# SHAPTON & PARTNERS INC.

Subject: Seismic Evaluation of City of Woodinville Annex Building Dear

SHAPTON & PARTNERS, INC. CONSULTING ENGINEERS	WOODINVILLE SCHOOL 13203 NE 175TH STREET SEISMIC EVALUATION	DATE: 06/22/01
		DETAIL NO. SK-1
FILE NO: 03502

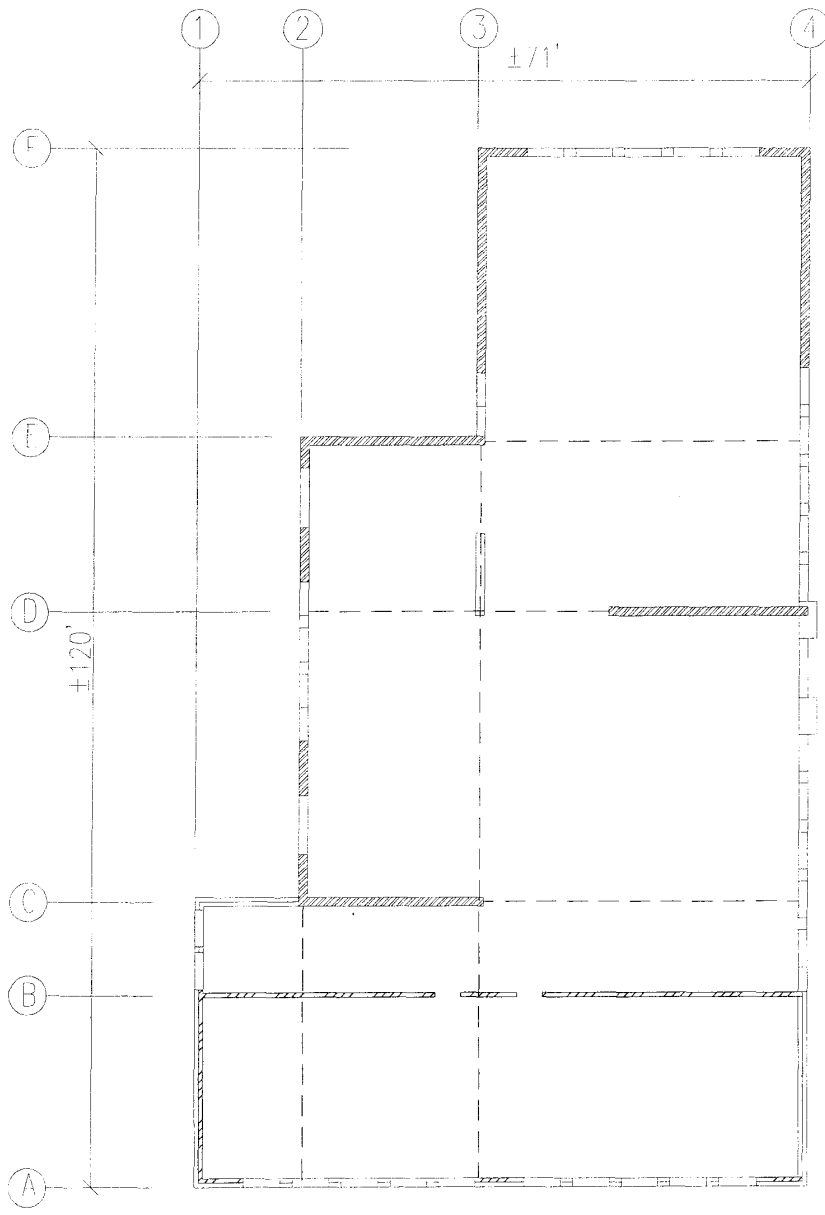
1. Horizontal loads originating from parts of the building which are remote from the shear resisting elements must be tied to the shear walls to provide for load transfer. The elements are known as collectors and are part of the floor/roof diaphragm construction. These elements are currently non-existent. This is a serious hazard since the diaphragms could fail prior to transferring horizontal shears to the shear resisting elements.

3. There is a deficiency in the strength of the diagonally sheathed wood shear walls along Line A (SK-1). This is a serious hazard as the failure of this line of bracing could be followed by the collapse of the building.

Sheathed Shear Walls. The diagonally sheathed wood shear wall on Line 1 was found to possess adequate shear capacity. The diagonally sheathed wood shear wall on Line A was found to be deficient in shear capacity.
